SUBJECT: Agenda Item–Traffic Committee Recommendations
April 19, 2006 – Postponed Item

A regular meeting of the Troy Traffic Committee was held Wednesday, June 21, 2006 in the Lower Level Conference Room at Troy City Hall. Pete Ziegenfelder called the meeting to order at 7:30 p.m.

3. Request for Sidewalk Waiver – 3838 Livernois

4. Reconsideration of Request for YIELD or STOP Sign on Ivanhoe at Sweet

SITE PLAN- DEVELOPMENT AREA

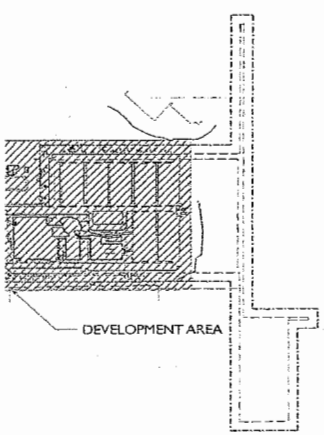
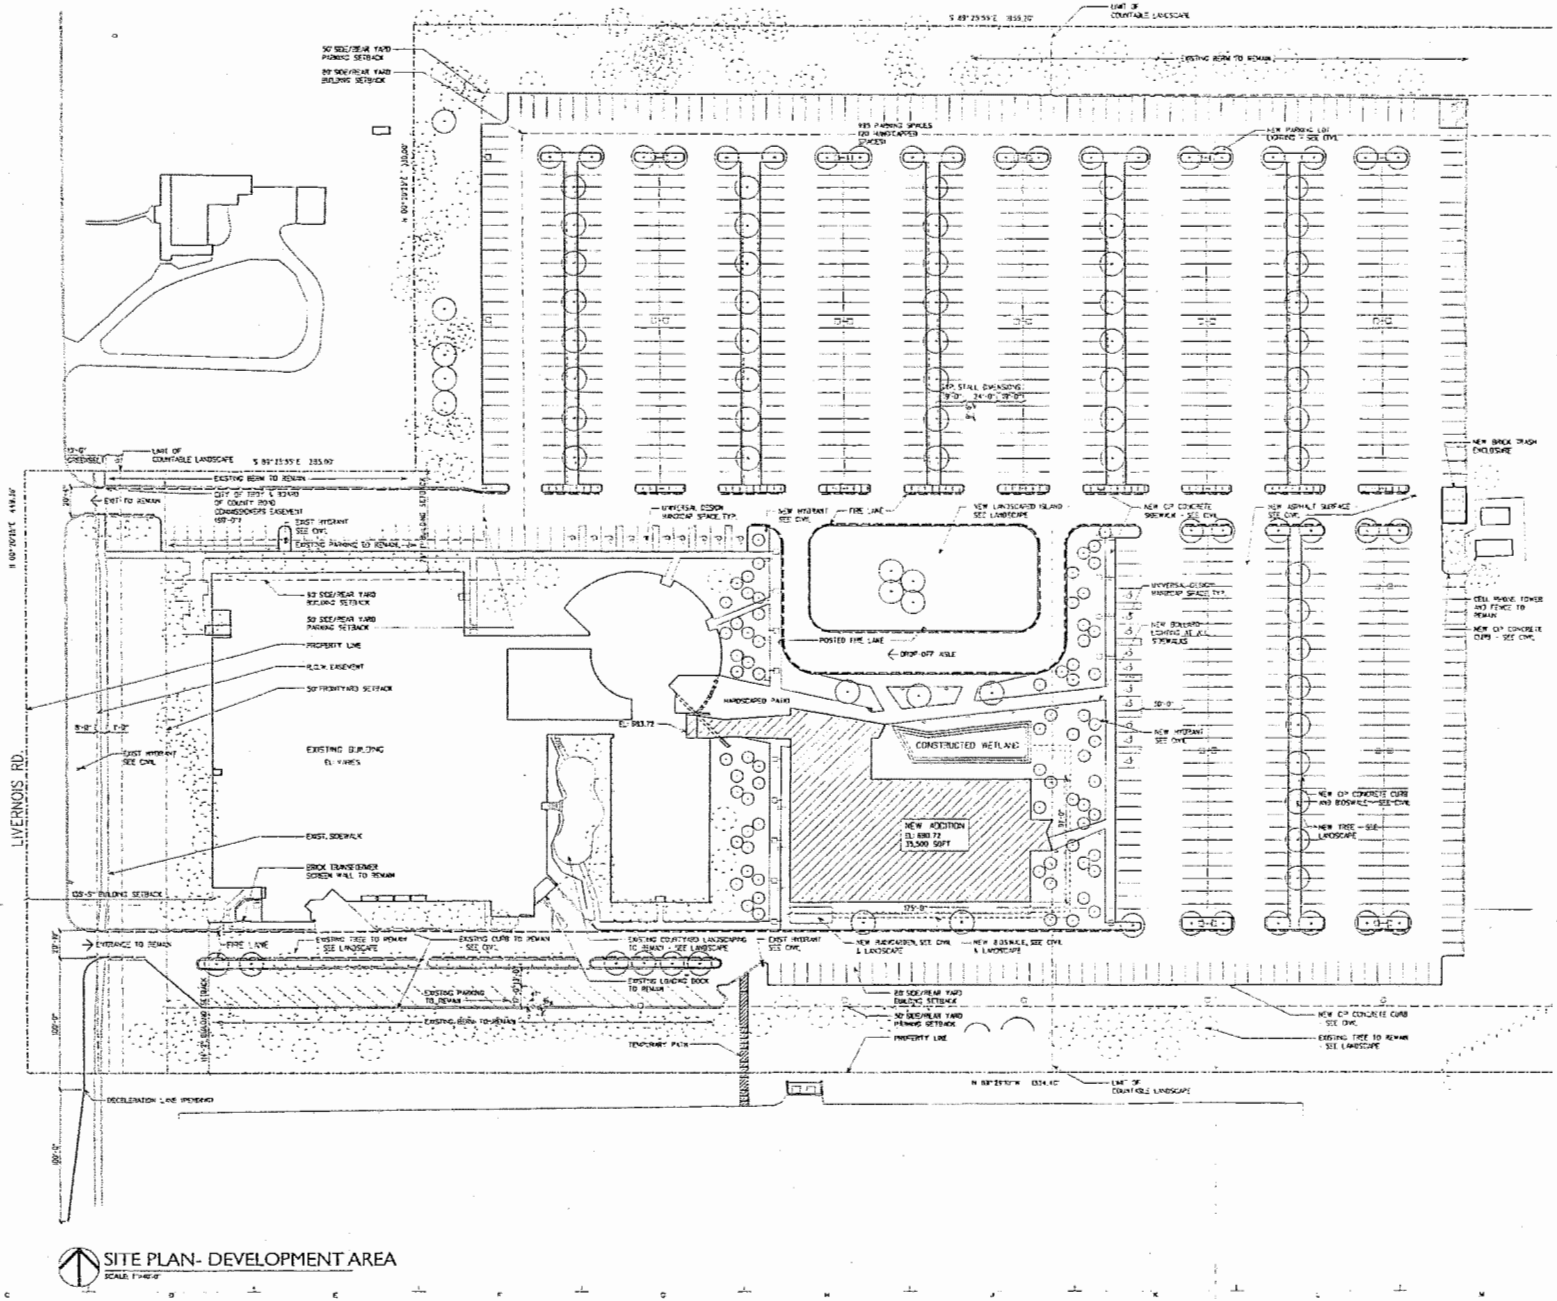
Walsh College is requesting a waiver for the sidewalk at 3838 Livernois. The sidewalk ordinance requires that the existing five-foot sidewalk be replaced with an eight-foot sidewalk, in conjunction with a building addition. The Public Works Department recommends denial of this waiver request. Petitioner has signed an "Agreement for Irrevocable Petition for Sidewalks."

Petitioner states that there are no other sidewalks to the north, and none on the south side that are 8 feet wide. The parcel to the north is designated a historic property, making it unlikely that the sidewalk will be continued northward

Helen Kieba-Tolksdorf, of Walsh College, addressed the committee and reiterated that there is little likelihood of sidewalk being installed to the north, and there is a five-foot sidewalk to the south. She believes there could be safety issues for pedestrians if Walsh had an eight-foot wide sidewalk that suddenly narrowed down to the current five-foot width at the south property line. She also pointed out that Walsh College is trying to keep their campus "green,' with more vegetation and less pavement. She mentioned that if there is a City project that would install eight-foot sidewalks north and south of Walsh College, they would be willing to participate in it and widen their sidewalk to eight feet.

WHEREAS, Walsh College has requested a temporary waiver of the requirement to construct an eight food wide sidewalk on the property because there are no other sidewalks in the area to the north, and no eight-foot wide sidewalks to the south; and

NOW THEREFORE, BE IT RESOLVED that the Traffic Committee grants a two-year waiver of the sidewalk requirement for the property at 3838 Livernois, which is owned by Walsh College.

ITEM 4

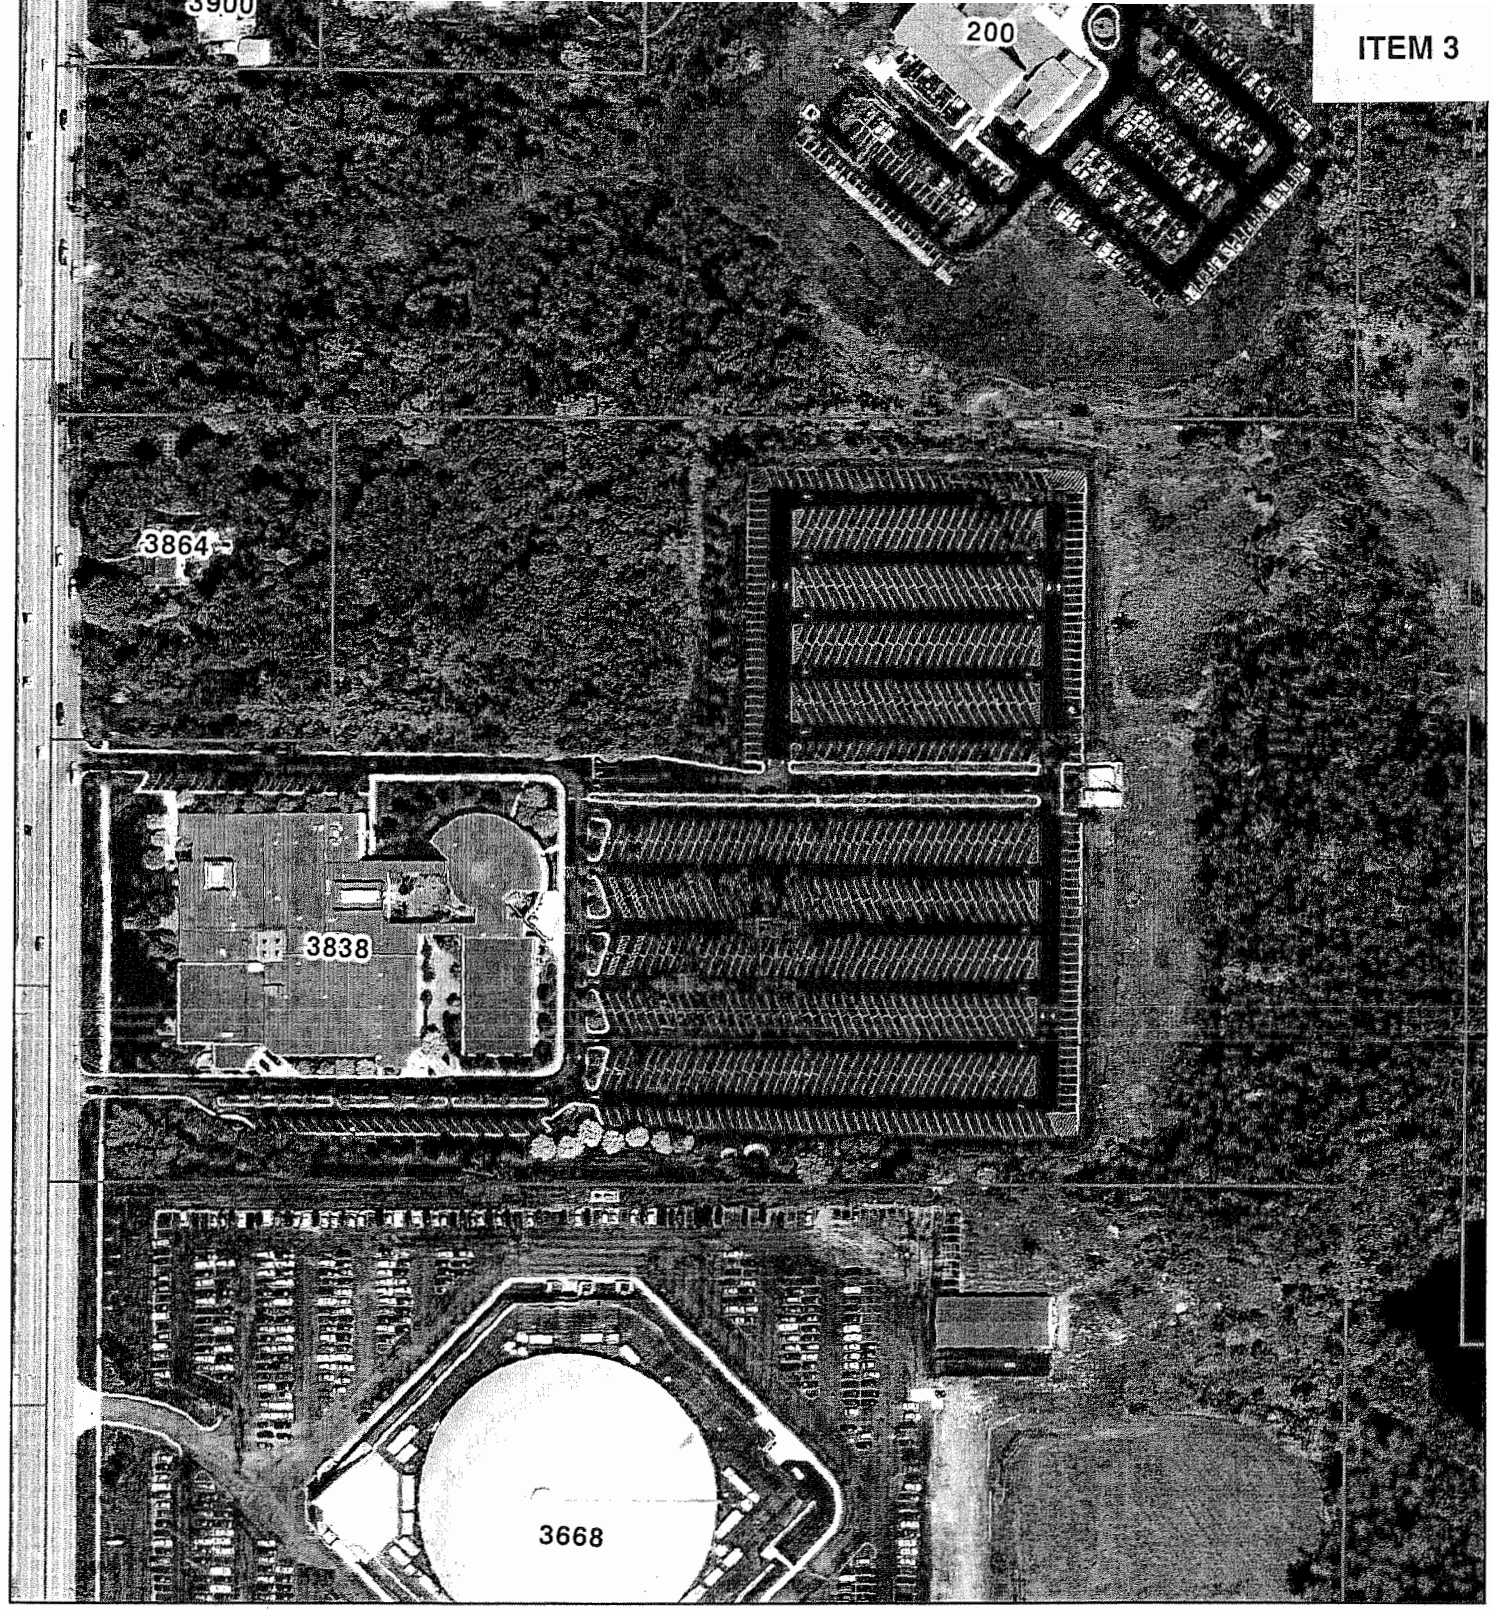
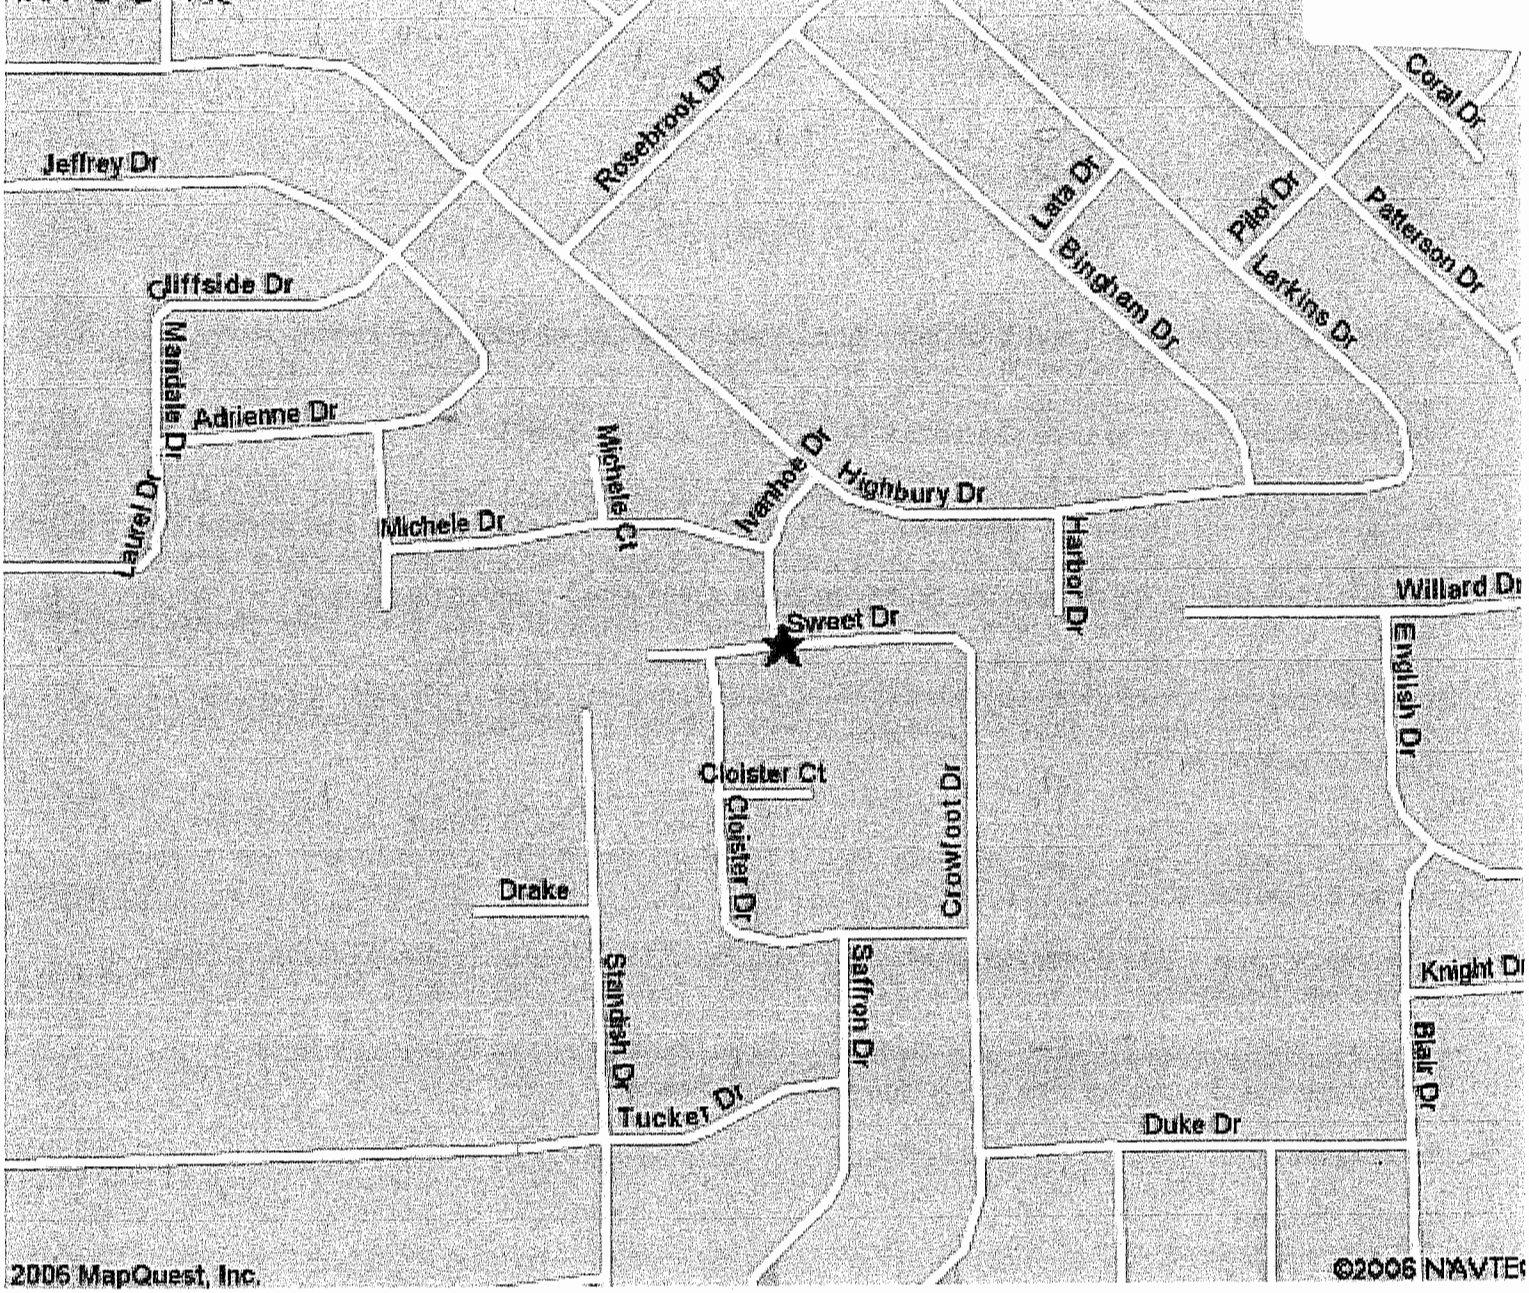
Sharyn Dennis, 2338 Sweet Drive, is requesting traffic control signs in the area of Sweet Drive and Ivanhoe Drive. She believes this is a dangerous intersection, since Ivanhoe connects her neighborhood with an older neighborhood, and allows for through traffic to John R via Ivanhoe and Highbury. She also reports constant high-speed traffic through the neighborhood.

A traffic crash analysis shows that there have been no reported crashes near Sweet and Ivanhoe in the past five years, which indicates that the intersection is relatively safe. Field observations show an evergreen tree in the northeast corner of the intersection. Our Parks & Recreation Department is looking into whether the tree is in the 25-foot clear-zone triangle.

Ms. Dennis reported to the committee that there have been near misses at the intersection, which is right in front of her driveway. There are conflicts when she tries to back out of her driveway. She also pointed out that Highbury runs off John R, and carries a lot of traffic. The Cloister/Saffron intersection has a YIELD sign and she feels a sign on Ivanhoe at Sweet would reduce risk of crashes and assign proper right of way to the motorists using the intersection.

Mr. Halsey checked the area and believes that a tree near the intersection causes a sight obstruction. Dr. Abraham will consult with the Parks Department.

To recommend installation of a YIELD sign on Ivanhoe at Sweet.

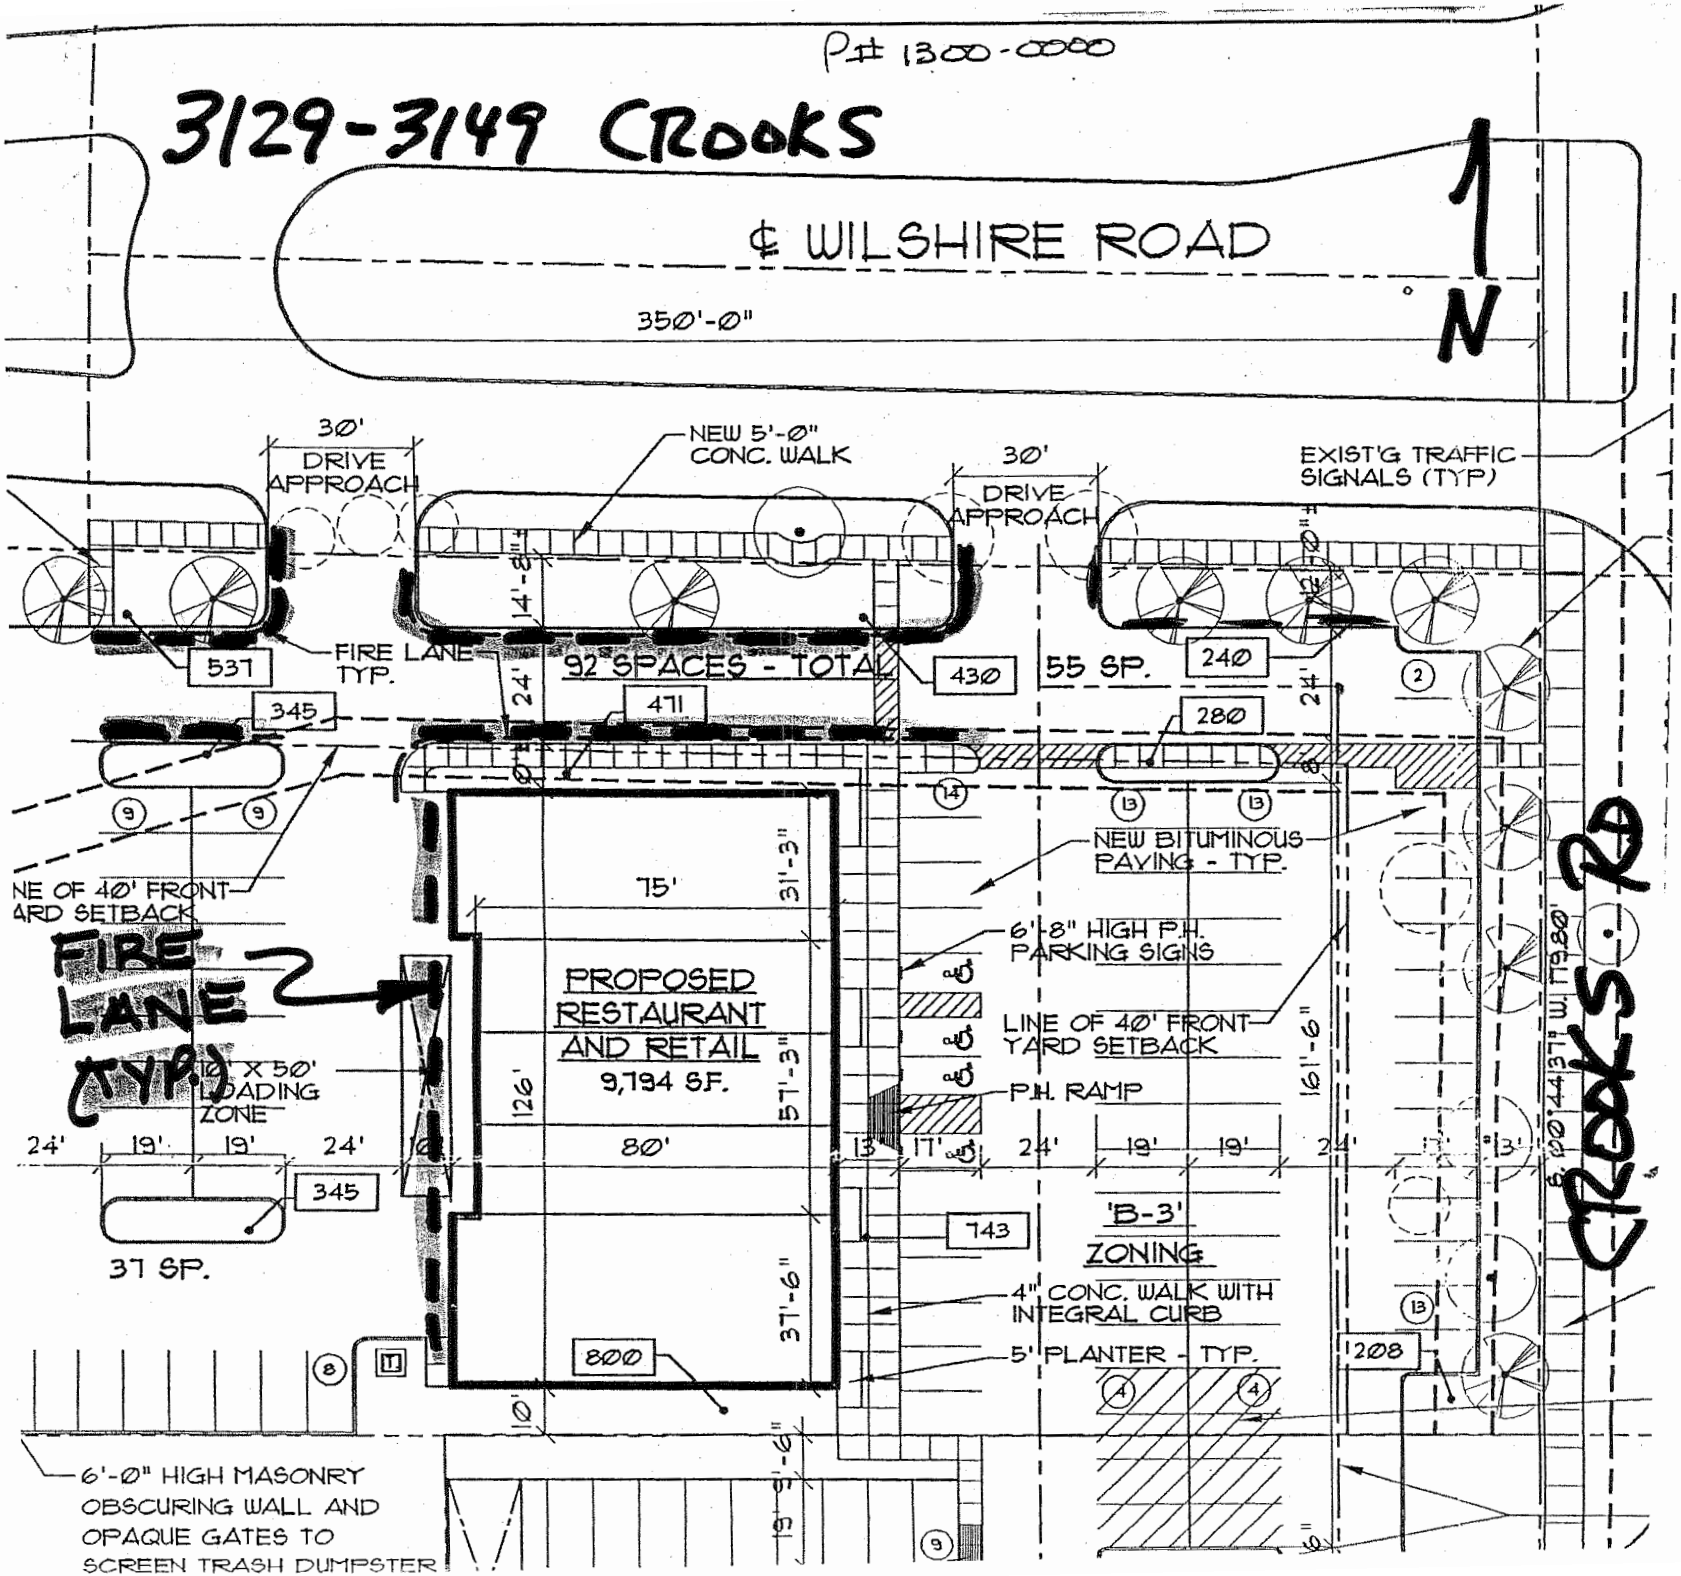
Lt. Matlick presented a sketch of recommended fire lanes at the new shopping center at 3129-3149 Crooks Road, at Wilshire.

Section 8.28, Chapter 106, Troy City Code, provides for the establishment of fire lanes on private property. The Fire Department recommends that the fire lanes shown on the attached sketch be provided to allow proper deployment of and travel by emergency vehicles (fire, police, medical).

Recommend establishing fire lanes at 3129-3149 Crooks Road per the Fire Department's recommendation.
